Subject: AP1000 Response to Request for Additional Information (SRP 3)

AP1000 TECHNICAL REPORT REVIEW

RAI Response Number: RAI-SRP3.8.2-CIB1-01

RAI Response Number: RAI-SRP-3.8.2-SEB1-03

Figure 1: Inadvertent Fan Cooler Case at $T = -40\text{ F}$

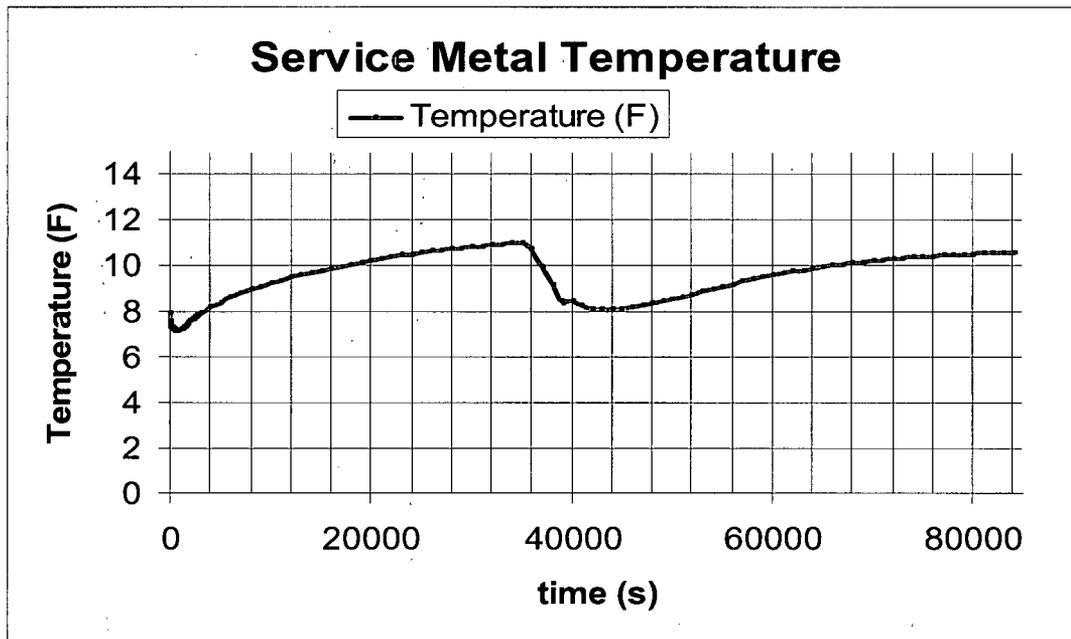
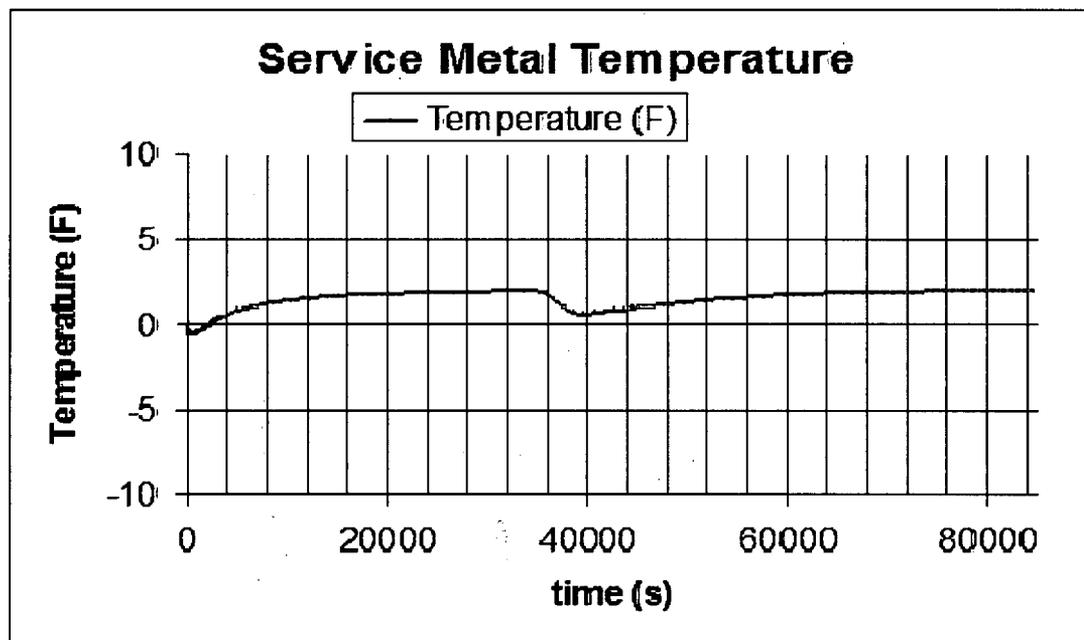
- 1) Please provide a plot of the containment shell temperature response in cold conditions discussed in the RAI response, similar to Figure E-1 provided in response to RAI-SRP-6.2.1.1-SPCV-07 (e). This plot covers the part of the transient used to establish steady-state initial conditions
- 2) Is the minimum service metal temperature of -18.5 °F in the AP1000 DCD based on the steady state result or the additional transient scenario discussed in your response to RAI-SRP-6.2.1.1-SPCV-07?

1. There is one transient type that challenges the minimum service metal temperature requirement of -18.5 F. These transients are an inadvertent actuation of the active containment cooling system (VCS). These transients are discussed in depth in RAI-TR09-008. Figure 1

depicts the inadvertent fan cooler operation case at the minimum safety analysis temperature of -40°F , and an additional case at -30°F . The WGOthic computer code was used to analyze these transients. Figure 1 shows the minimum service metal temperature for the inadvertent fan cooler case. The transient was completely contained in one case. The case was allowed to equilibrate for 35000s before transient initiation. Operator action is assumed to occur within 60 minutes to shut off the fan coolers and return the transient to normal conditions. Figure 2 depicts the inadvertent fan cooler case at -30°F . This case is evaluated for containment shell temperature because wind speed at -30°F ambient condition is recorded to be faster than at -40°F resulting in a higher velocity through the annulus between the containment and air baffle and therefore greater heat transfer. The increased heat transfer results in a lower shell temperature. For Figures 1 and 2 the minimum service metal temperature is 7.18°F for the -40°F case and -0.61°F for the -30°F case. The transient cases along with the entire spectrum of analyses considering the external pressure and minimum service metal temperature can be found in APP-MV50-Z0C-039 Rev. 0.
